# DUTCH BROS. COFFEE - CO0907, COLORADO SPRINGS, CO

## SITE DEVELOPMENT PLAN

COVER SHEET  
5810 OMAHA BLVD  
COLORADO SPRINGS, CO 80915

PPR2413

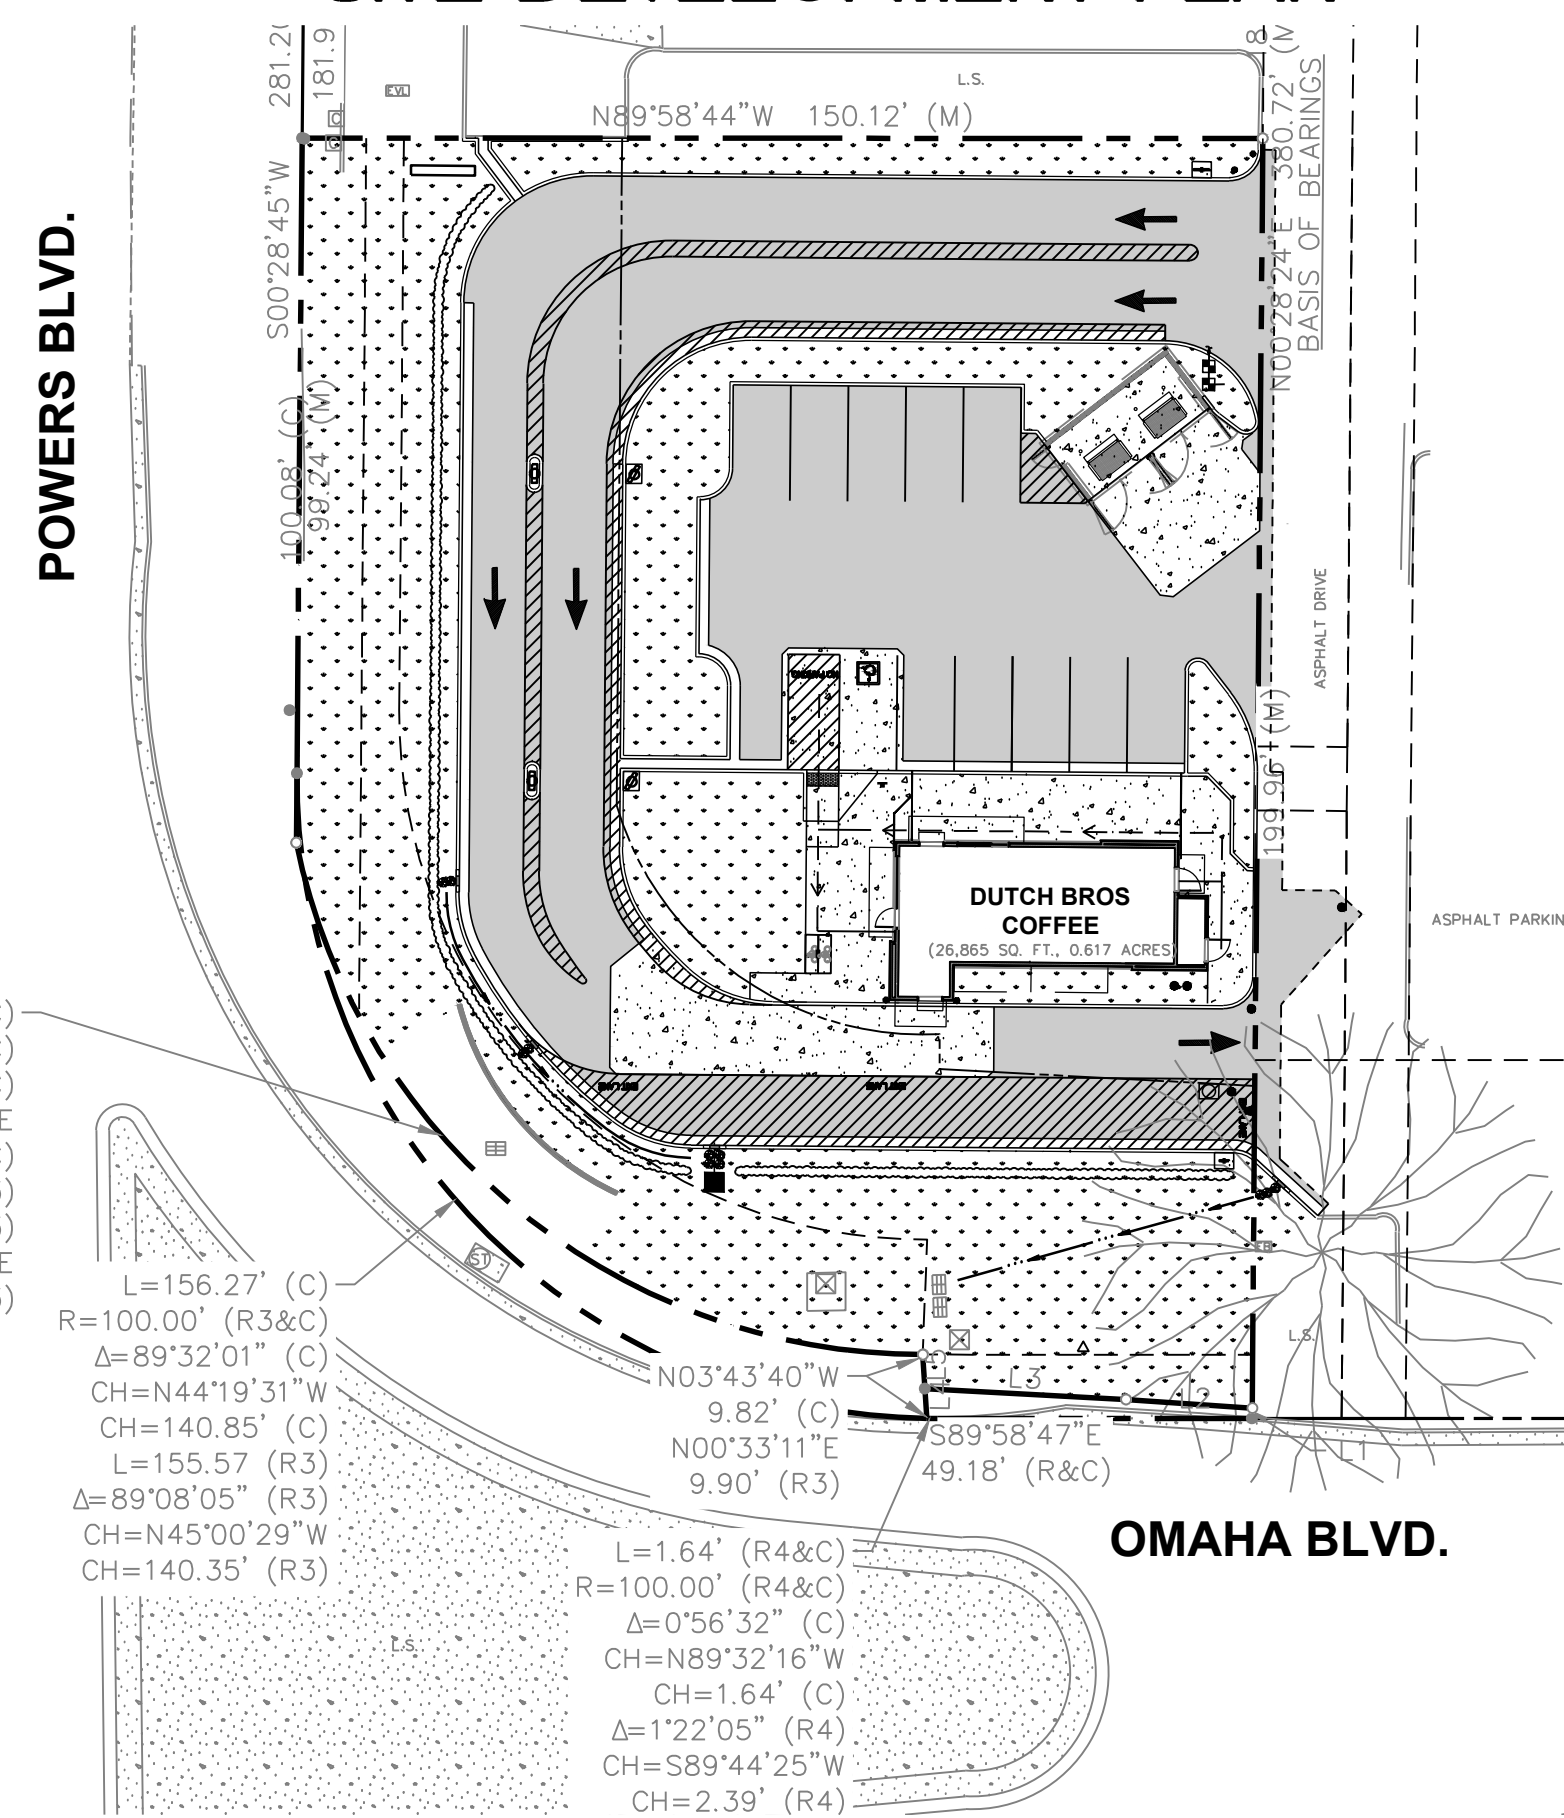
Please remove the "Not for Construction" Stamp from all pages that contain it
